Colorado Department
of Public Health
and Environment

Modifications to the Rocky Flats Cleanup Agreement Available for Public Comment

**Technical Basis Document for the Proposed
Modification to the Rocky Flats Cleanup Agreement
Attachments to Implement Integrated Risk-Based Accelerated
Action Framework**

PROPOSED MODIFICATIONS TO ATTACHMENT 5 – ACTION LEVEL FRAMEWORK FOR SURFACE WATER, GROUND WATER, AND SOILS

**RFCA
Attachement 5
Figure 1**

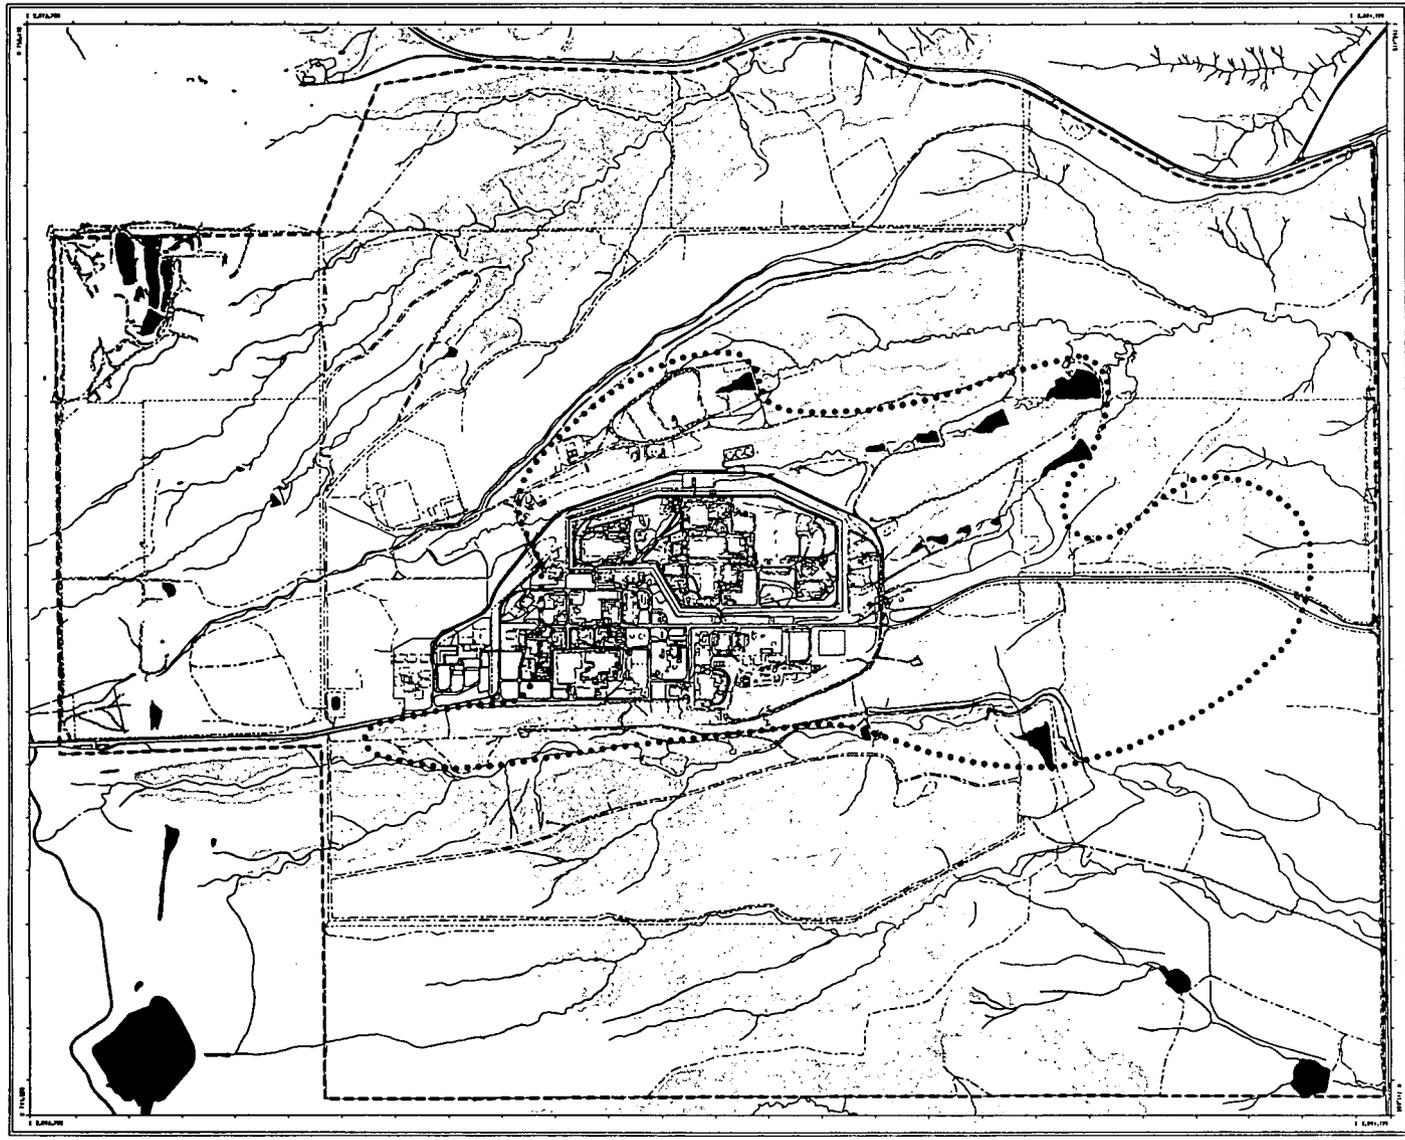
4.1.1.1 Figure 1, Conceptual Land Uses at RFETS

Figure 1 is modified to replace the current assumed boundaries for the five conceptual land uses. A new boundary is indicated for the area of the Site within which institutional controls will be used to prevent unacceptable exposure from residual contamination. The areas of the Site where landslide potential exists are also shown.

- Areas of landslides and high erosion. Contaminated sites within these areas must be evaluated per Risk Screen 2 of Figure 3.
- ⋯ The anticipated boundary of areas that will be subject to institutional controls is subject to modification based upon characterization, future response actions, the results of the comprehensive risk assessment, and the final remedial/corrective action decision in the final CAD/ROD.

Figure 2. Sketch of Stream Segments 4a/4b and 5.

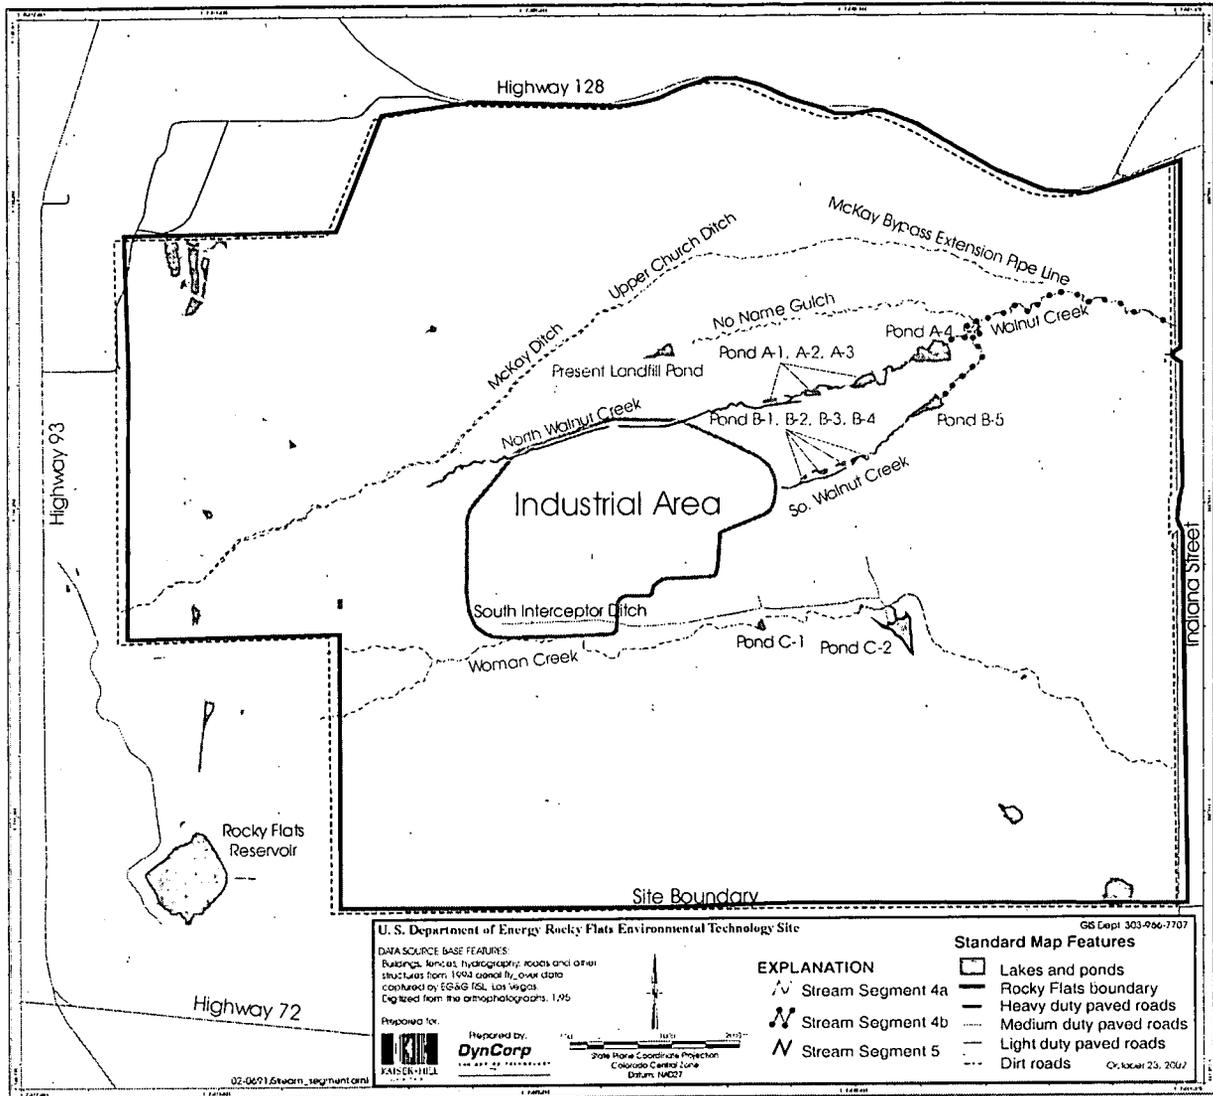
4.1.2.1 Figure 2, Sketch of Stream Segments 4a/4b and 5

This is a new Figure to accompany the narrative description in section 2.1.

Figure 3: Soil Risk Screen

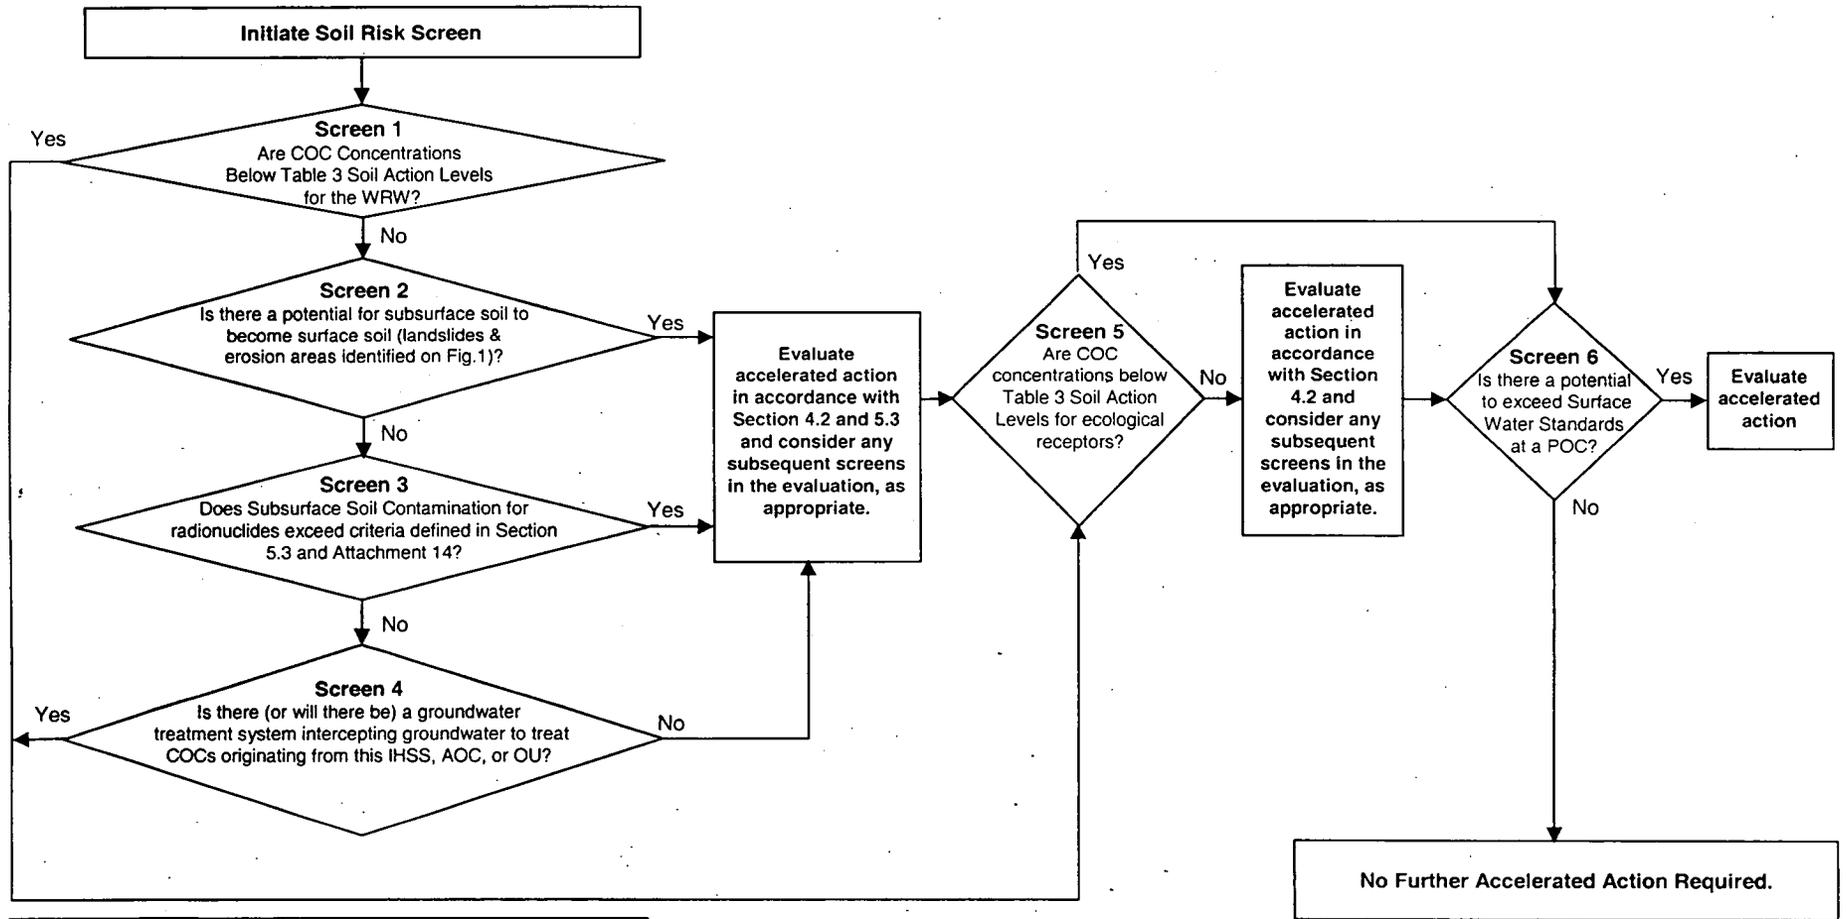
4.1.4.3 Figure 3, Soil Risk Screen

A new Figure 3, *Soil Risk Screen*, is proposed. This is a key element to implement the proposed integrated risk-based approach.

- C. Where soil contamination is identified below 6 inches in depth, the Soil Risk Screen, Figure 3, will be used to evaluate the potential risk of exposure and the need for further action.

- H. Soils beneath “below-grade” structures, e.g., basements, valve vaults, pits, etc., will be addressed through the application of the Soil Risk Screen in Figure 3.
